TRANS/WP.29/2003/78
30 July 2003

DRAFT CORRIGENDUM 1 TO THE 04 SERIES OF AMENDMENTS
TO REGULATION No.16

(Safety belts)

Transmitted by the Working Party on Passive Safety (GRSP)

Figure 1 – ISO/F3 envelope dimensions for a full-height forward-facing toddler CRS (height 720 mm) - ISOFIX SIZE CLASS A

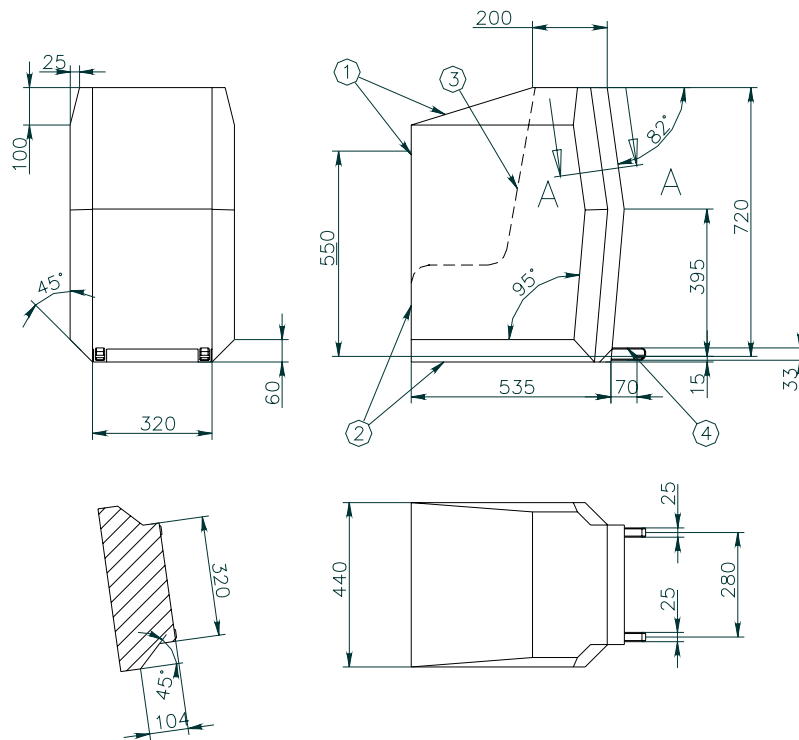
Paragraphs 4.1. and 4.2., amend to read:

"4.1. Full-height forward-facing toddler child restraint systems envelope

Figure 2 – ISO/F2 envelope dimensions for a reduced-height forward-facing toddler CRS, (height 650 mm) – ISOFIX SIZE CLASS B"

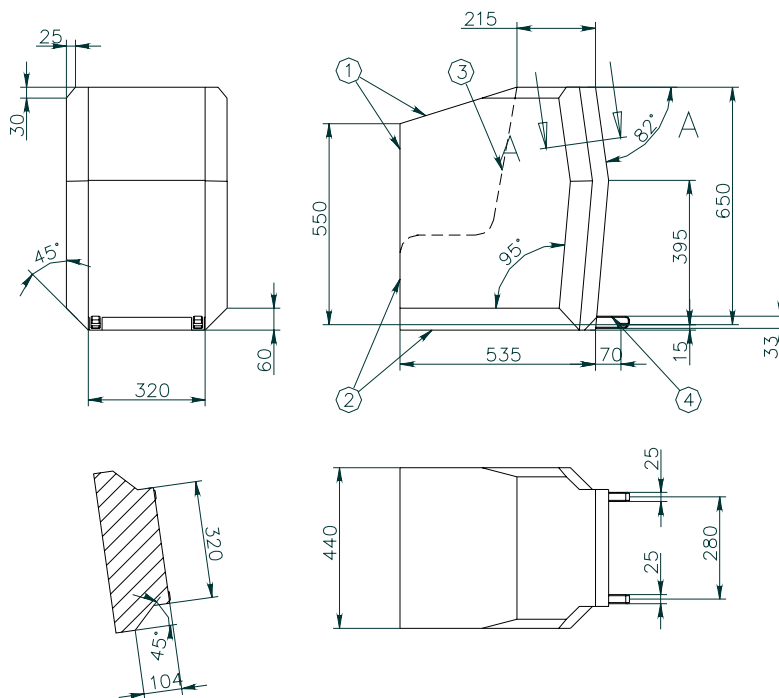
4.2. Reduced-height forward-facing toddler child restraint systems envelope

Figure 3 – ISO/F2X envelope dimensions for a reduced-height second version back surface shape forward-facing toddler CRS, (height 650 mm) – ISOFIX SIZE CLASS B1"

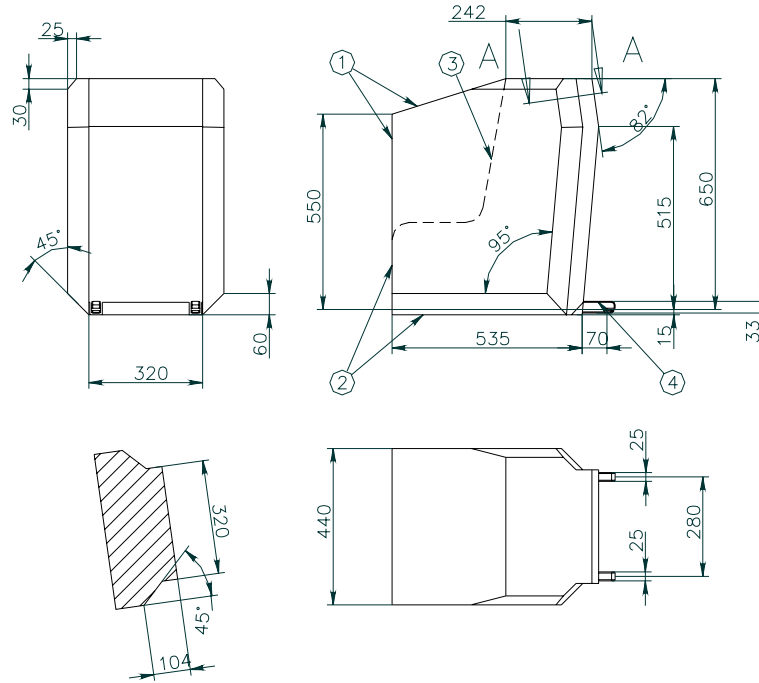
Insert a new paragraph 4.3., to read:

"4.3. Reduced-height second version back shape forward-facing toddler child restraint systems envelope

Figure 4 – ISO/R3 envelope dimensions for a full-size rearward-facing toddler CRS – ISOFIX SIZE CLASS C

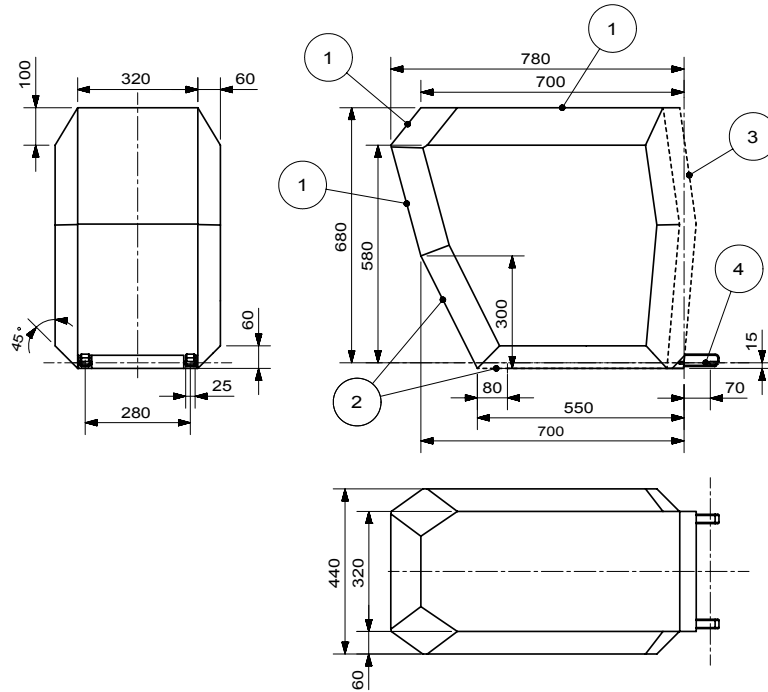
Paragraphs 4.3. to 4.6. (former), renumber as paragraphs 4.4. to 4.7., and amend to read:

"4.4. Full-size rearward facing toddler child restraint system envelope

Figure 5 – ISO/R2 envelope dimensions for a reduced-size rearward-facing toddler CRS – ISOFIX SIZE CLASS D

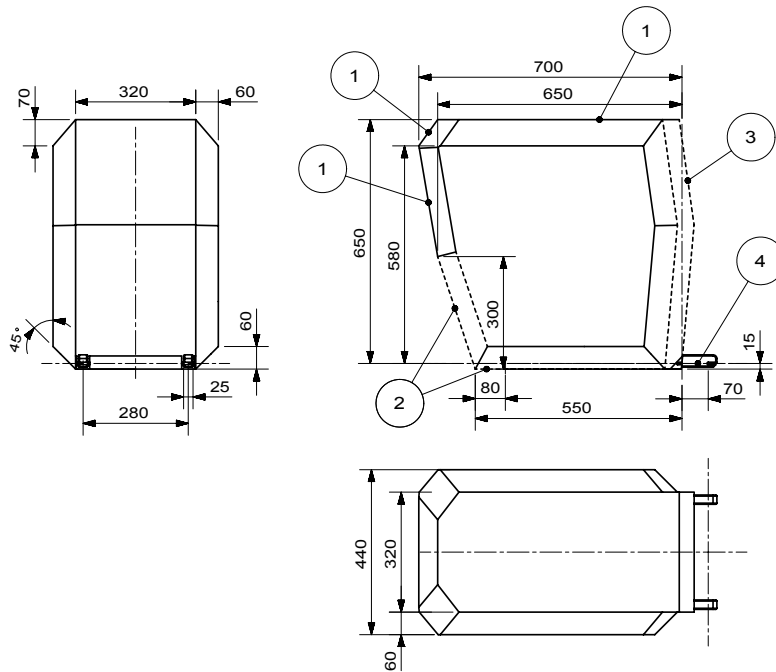
4.5. Reduced-size rearward-facing toddler child restraint systems envelope

Figure 6 – ISO/R1 envelope dimensions for an infant-size rearward-facing CRS – ISOFIX SIZE CLASS E

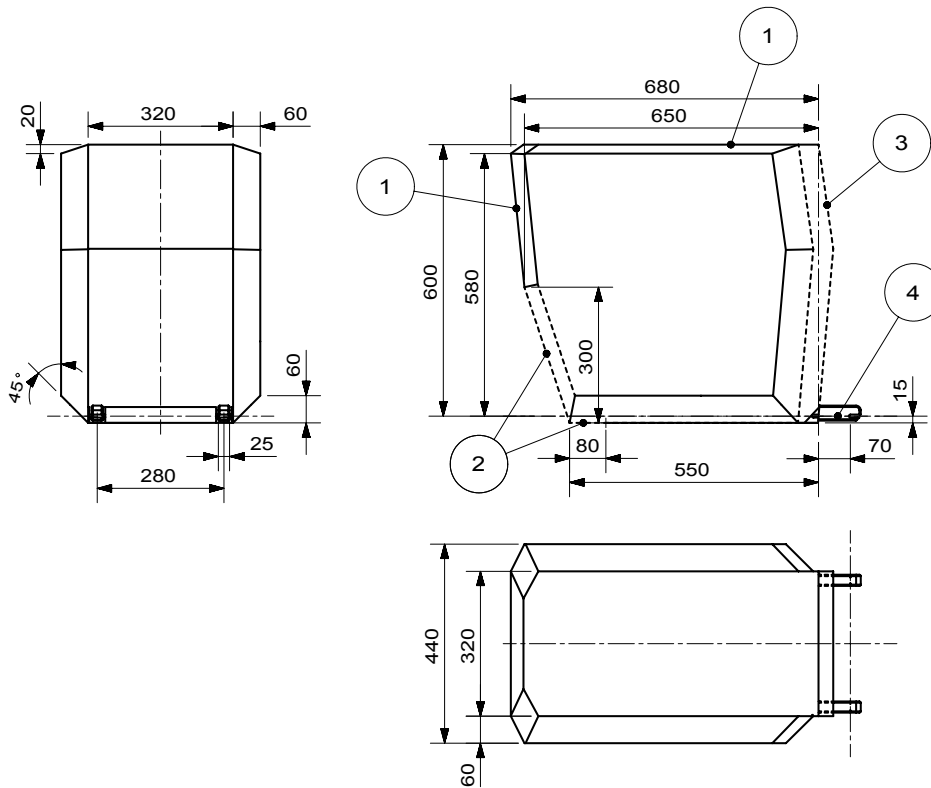
4.6. Rearward facing infant child restraint systems envelope

Figure 3 RF 1 Revised

Figure 7 – Envelop dimensions for lateral facing position CRS - ISO/L1-ISOFIX SIZE CLASS F or symmetrically opposite – ISO/L2 – ISOFIX CLASS G"

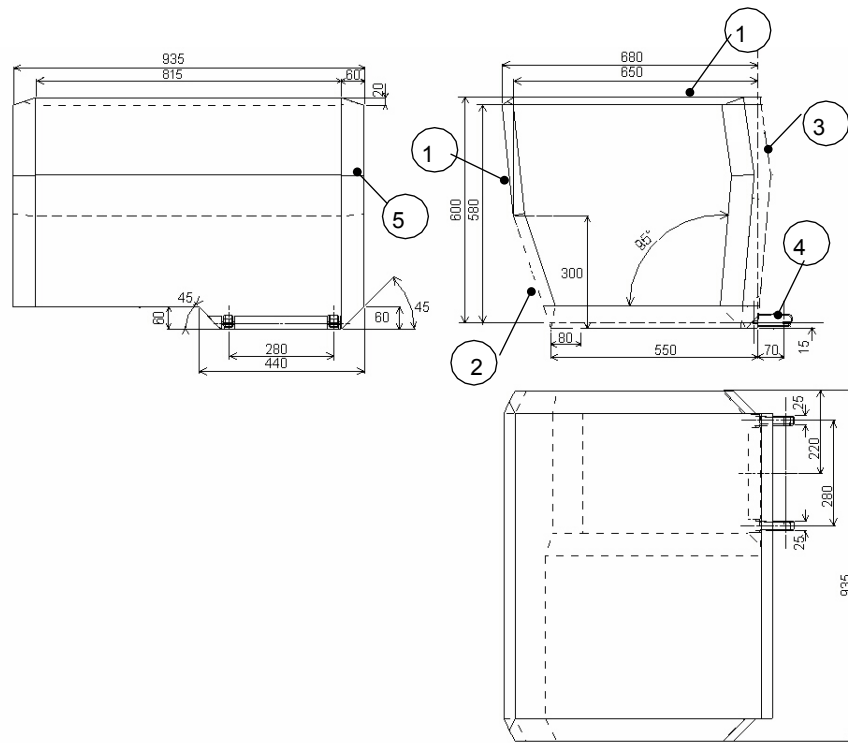
4.7. Lateral facing child restraint systems envelope
